FIELD AND DEPOT MAINTENANCE MANUAL TEST SETS, ELECTRON TUBE TV-2/U, TV-2A/U, TV-2B/U, AND TV-2C/U

CHANGE No. 1

HEADQUARTERS DEPARTMENT OF THE ARMY WASHINGTON, D.C., 6 February 1964

TM 11-6625-316-35, 8 September 1961, is changed as follows:

Figure 26. Test Set, Electron Tube TV-2(*)/U, schematic diagram

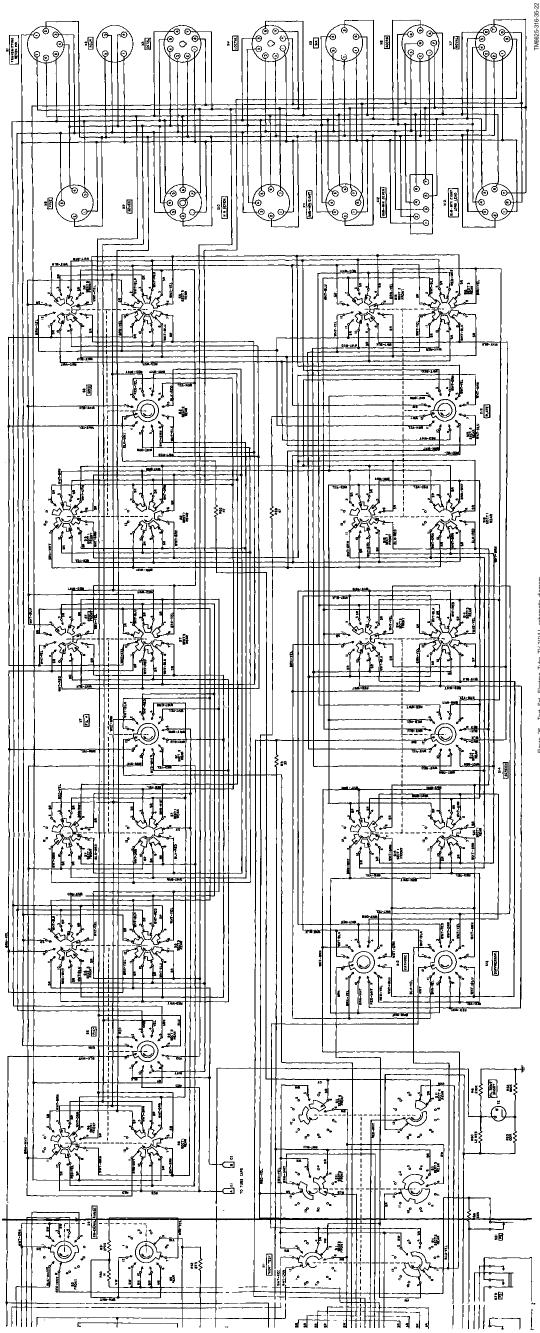
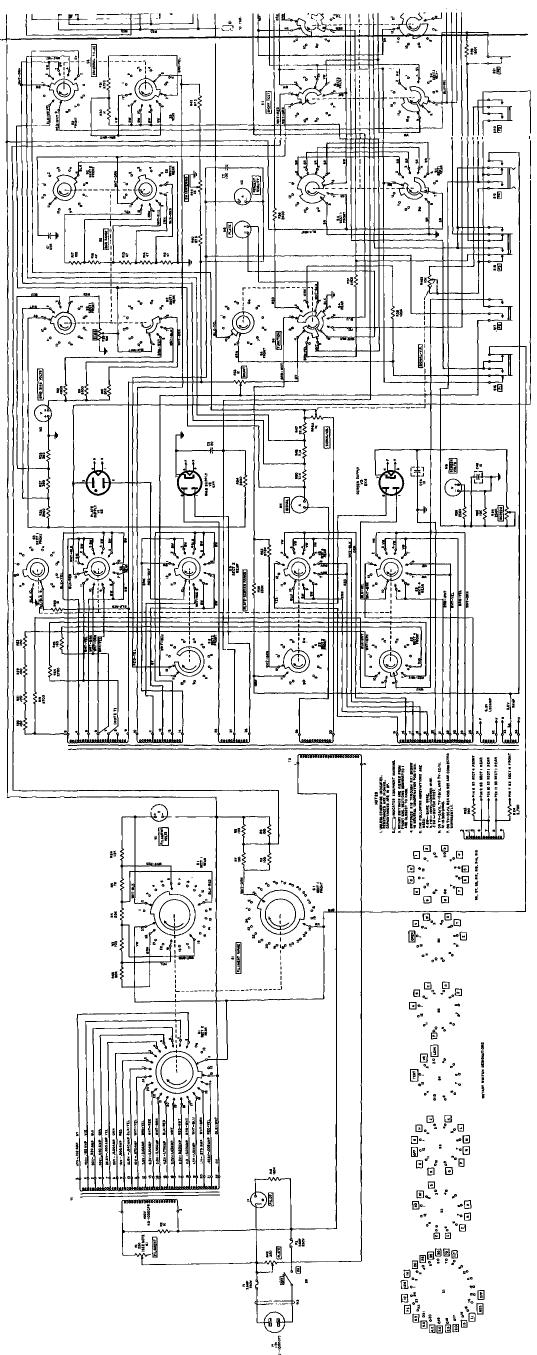
Page 44, figure 26 (Foldout, 1st part). In the top right corner of the illustration, on Switch S2, Section 2, front, add a connection line from Contact 11 to the upper (ungrounded) end of capacitor C 1.
